# **TUALATIN ARCHITECTURAL REVIEW BOARD**

June 10, 2015, 6:30 PM POLICE TRAINING ROOM 8650 SW TUALATIN RD TUALATIN, OR 97062

- A. Koch Manufacturing Expansion Project Recommendation and Staff Report for AR-15-05.
- 5. **COMMUNICATIONS FROM BOARD MEMBERS**
- 6. **ADJOURNMENT**

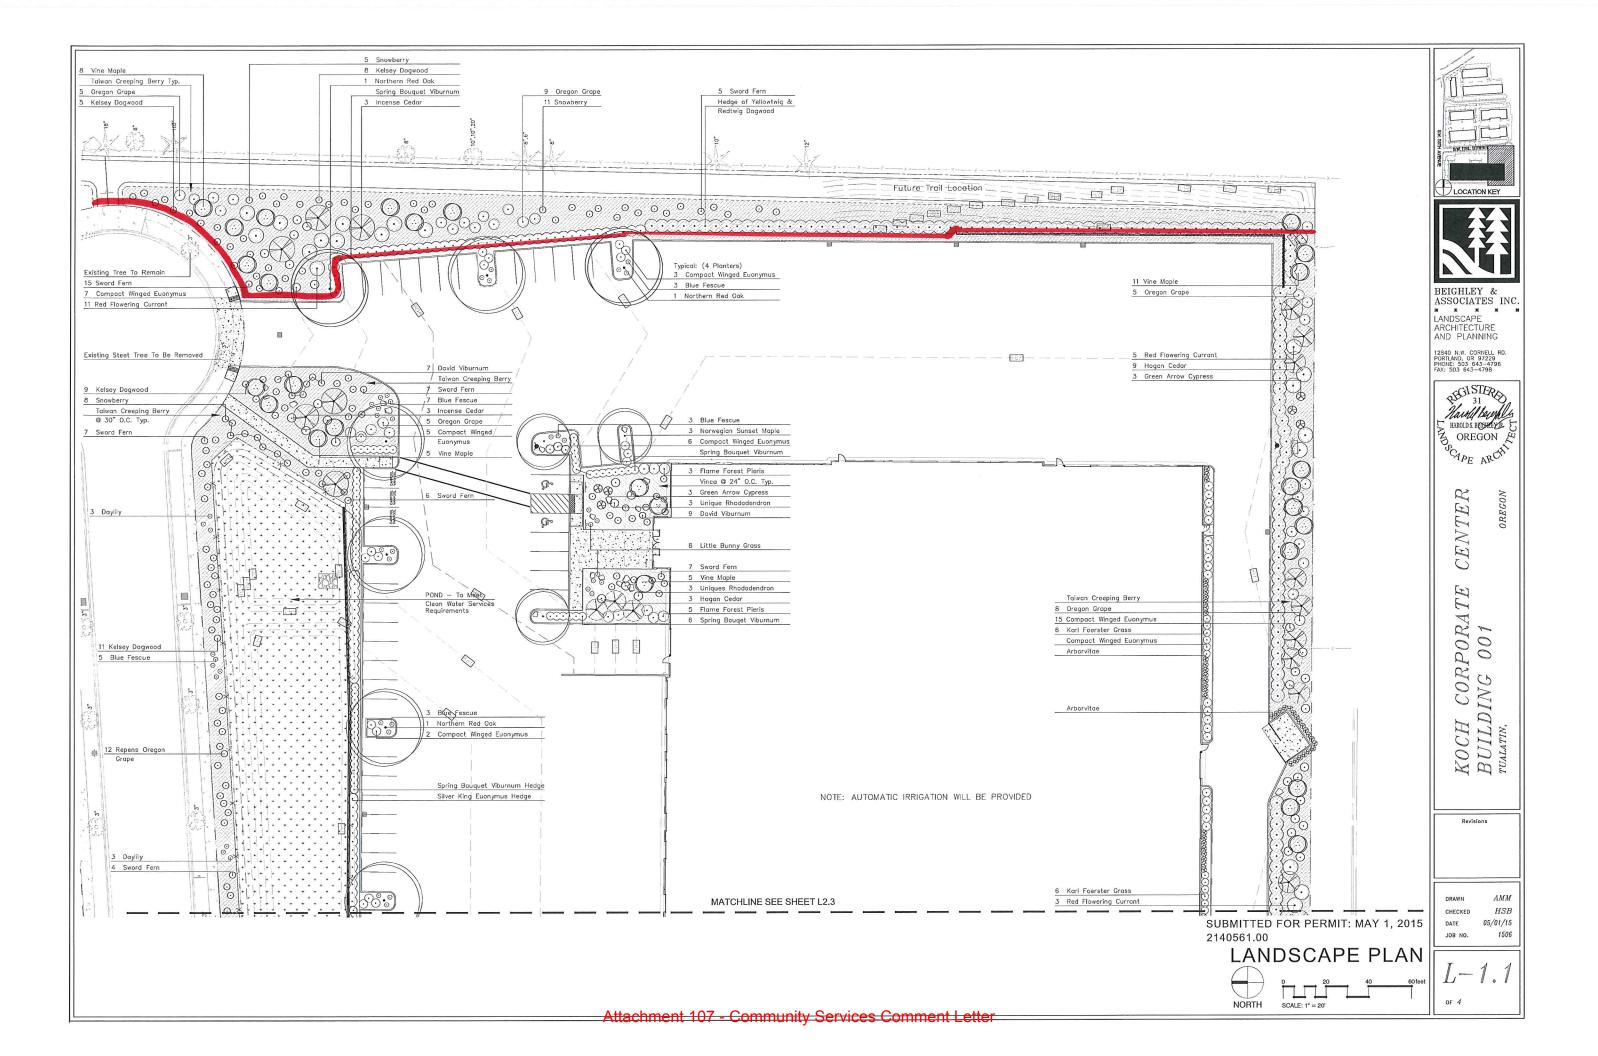
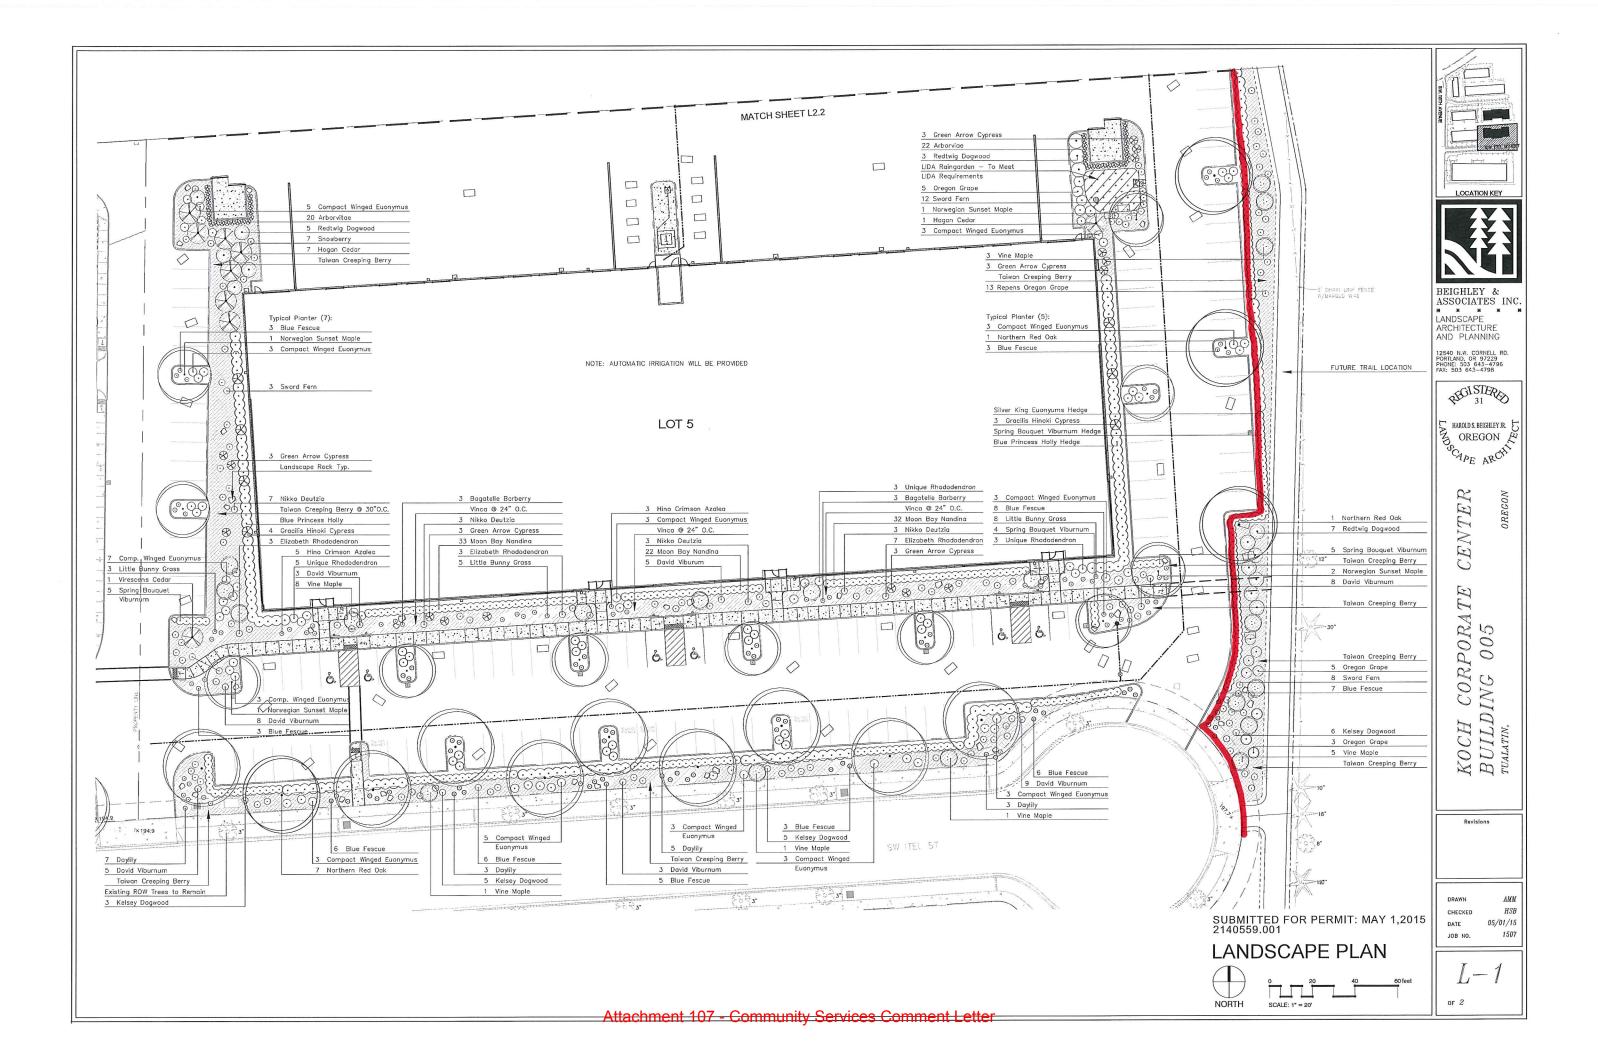
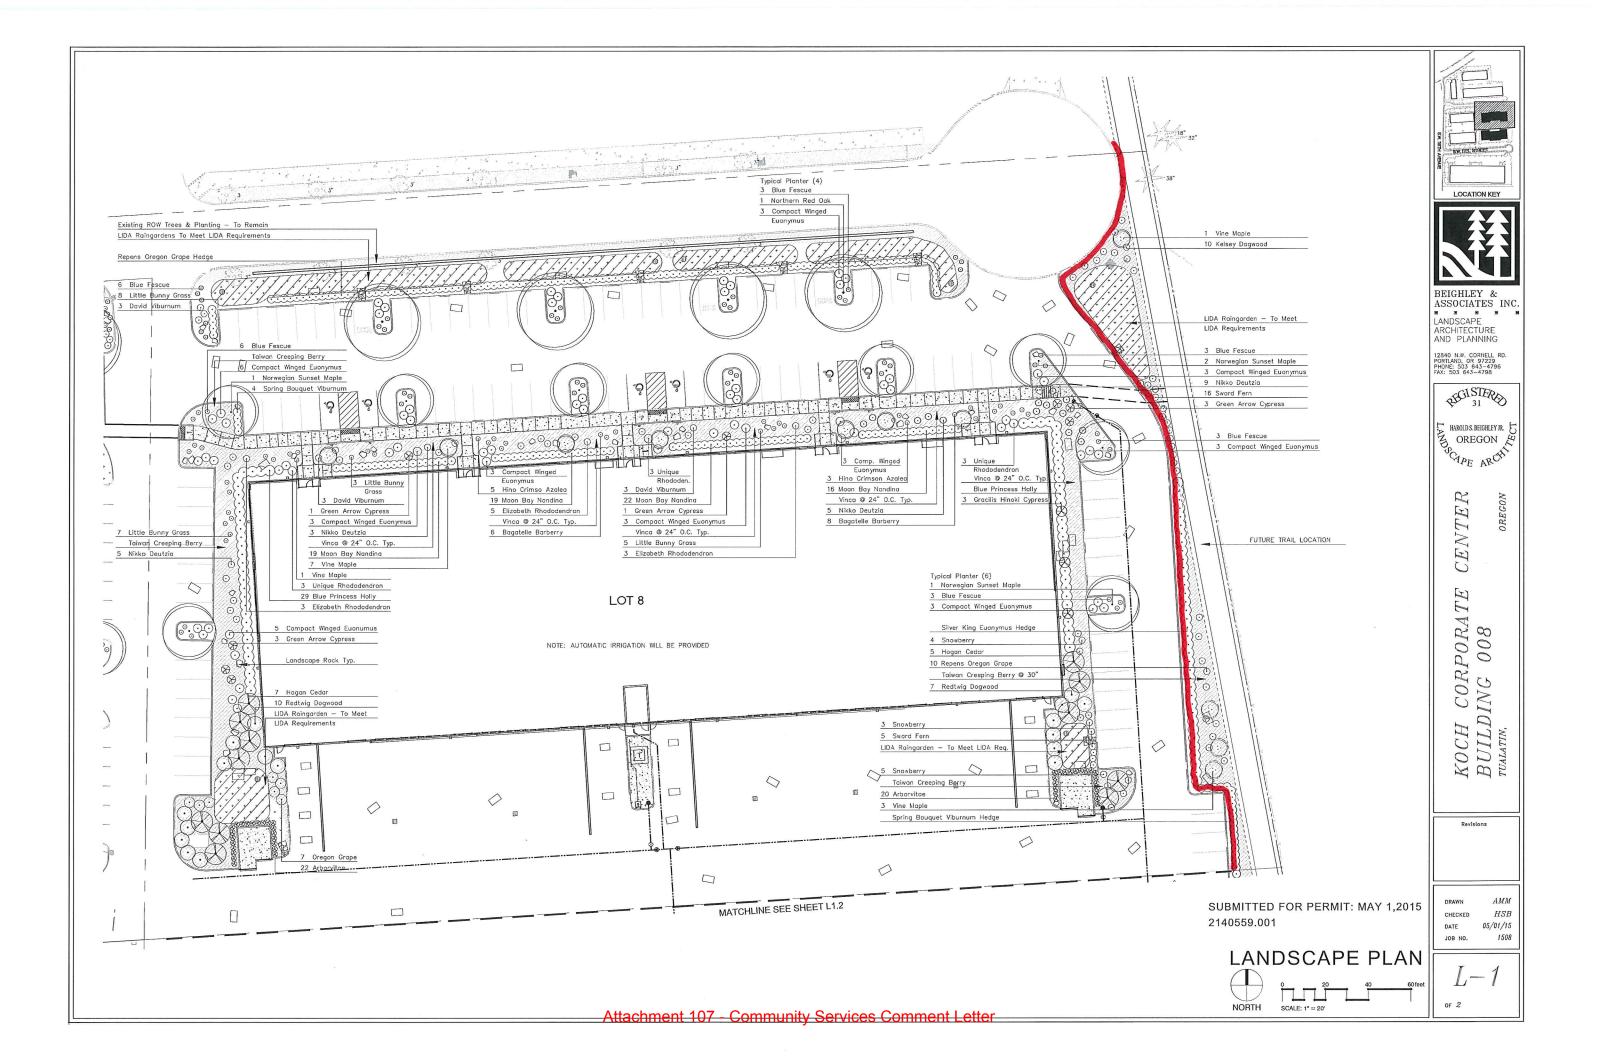
The Community Services Department has reviewed the materials provided with the Application and has the following comments.

The applicant shall grant an easement to accommodate a 14 foot shared use pathway. The easement area shall vary in width between 14 and 20 feet along the eastern property boundary as shown on attached Site Plans L-1, L-1.1 and unnamed (3 pages).
